ATTN: Document Control Desk
U.S. Nuclear Regulatory Commission
Washington, DC 20555-001**SUBJECT:**Davis-Besse Nuclear Power Station
Docket No. 50-346, License No. NPF-3
Completion of Required Action by NRC Order EA-12-051, Reliable Spent Fuel Pool
Instrumentation (CAC No. MF0960)

NRC Requests for Information
Page 1 of 28

By letter dated December 11, 2013, the Nuclear Regulatory Commission (NRC) issued an interim staff evaluation (ISE) and request for additional information (RAI) regarding the Davis-Besse Nuclear Power Station (DBNPS) overall integrated plan for implementation of NRC Order EA-12-051, Reliable Spent Fuel Pool Instrumentation. Subsequently, by letter dated March 26, 2014, the NRC staff transitioned to an audit-based review process that allowed the use of the licensee's ePortal to provide responses to the RAIs to support the staff's review process. FirstEnergy Nuclear Operating Company (FENOC) utilized the ePortal to provide the majority of RAI responses for DBNPS. The responses to the following RAIs were previously provided to the NRC via the FENOC ePortal: RAI-4(b) schematic, RAI-5, RAI-7, RAI-8, RAI-10(b), RAI-11, RAI-12, RAI-13, RAI-14, and RAI-15. The previousl

DBNPS Critical Level Elevations and Measurement Range

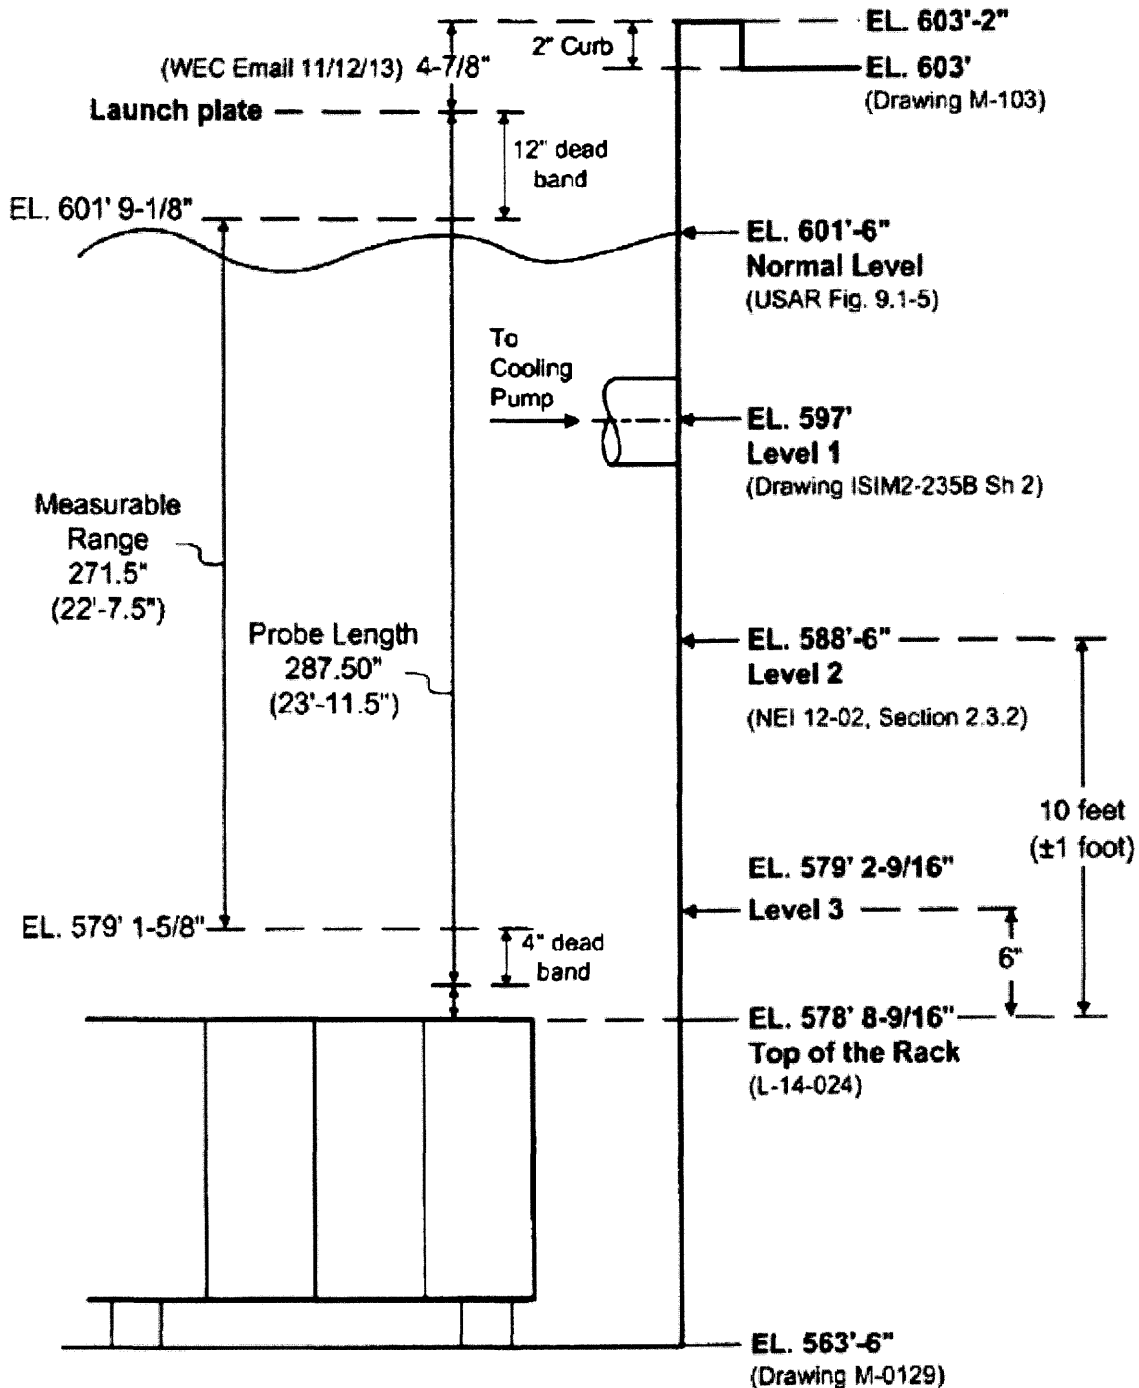
Please provide a clearly labeled sketch depicting the elevation view of the proposed typical mounting arrangement for the portions of the instrument channel consisting of permanent measurement channel equipment (e.g., fixed level sensors and/or stilling wells, and mounting brackets). Indicate on this sketch the datum values representing Level 1, Level 2, and Level 3, as well as the top of the fuel racks. Indicate on this sketch the portion of the level sensor measurement range that is sensitive to measurement of the fuel pool level, with respect to the Level 1, Level 2, and Level 3, datum points.

The response to this RAI was provided by FENOC letter dated February 27, 2014. Subsequently, more refined measurements were obtained for the top of fuel rack and bottom of measurement range. An updated sketch is provided below.

SCALE NONE	DESIGNED	DRAWN	DATE
DAVIS-BESSE NUCLEAR POWER STATION UNIT NO. 1			
CONDUIT ROUTING FOR ECP 13-0596-001			
FENOC	DRAWING NO.	SHEET NO.	REV.
	FSK-E-0205	1	0

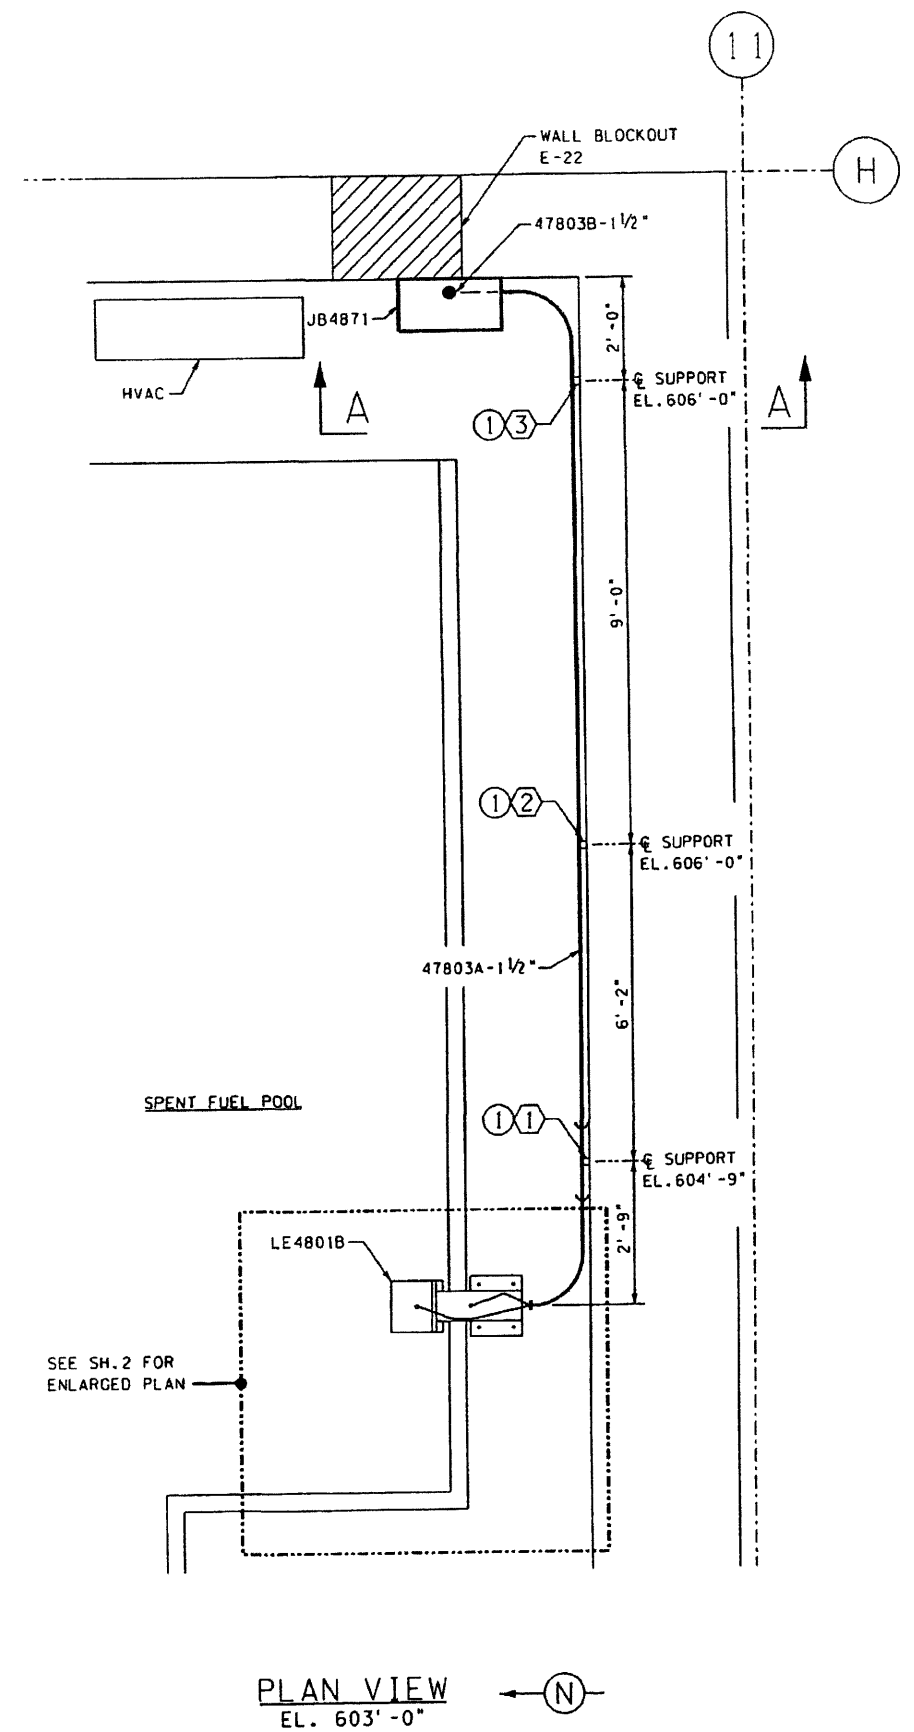
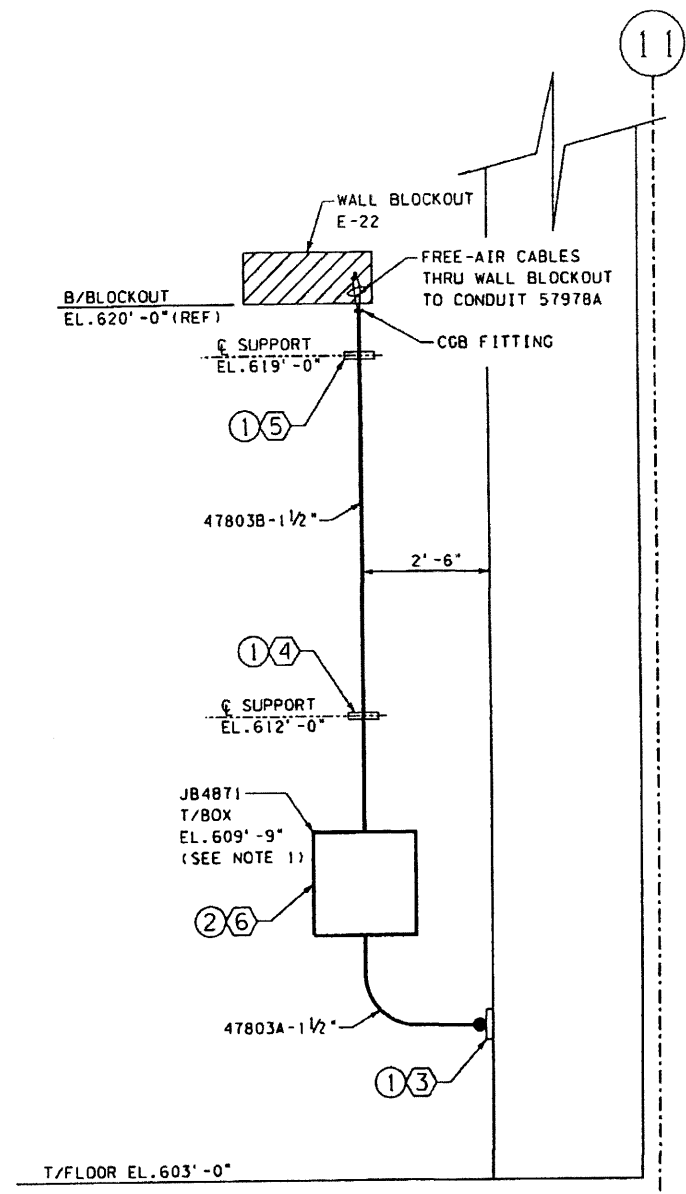
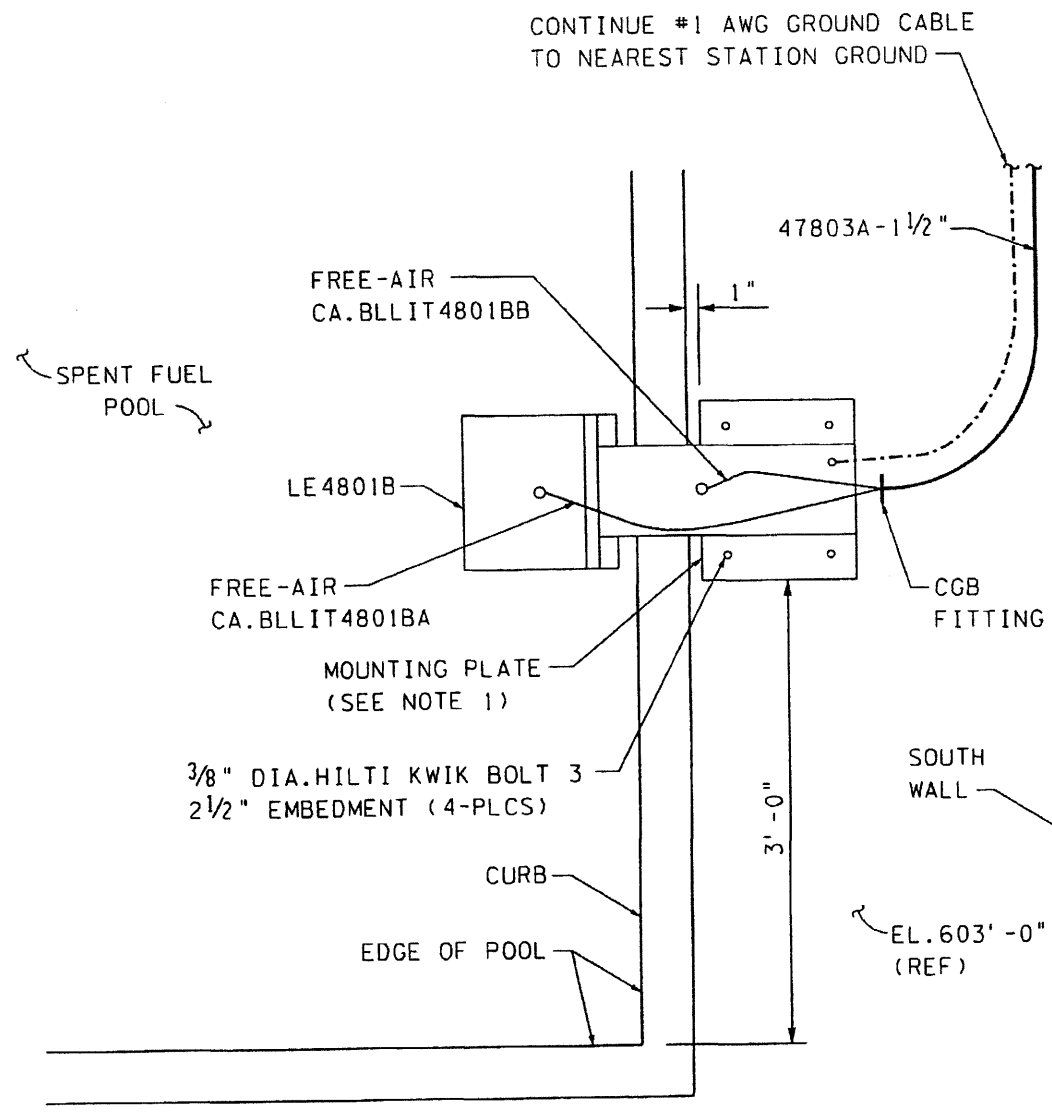
Please provide a clearly labeled sketch or marked-up plant drawing of the plan view of the SFP [spent fuel pool] area, depicting the SFP inside dimensions, the planned locations/placement of the primary and back-up SFP level sensor, and the proposed routing of the cables that will extend from these sensors toward the location of the read-out/display device.

The response to this RAI was provided by FENOC letter dated February 27, 2014. The location of the backup level sensor, DB-LE4801B, was indicated to be on the south deck of the southeast corner of the SFP. The final location of the backup level sensor is on the south deck of the southwest corner of the SFP. Updated sketches for the location of DB-LE4801B are provided below, depicting general configuration.
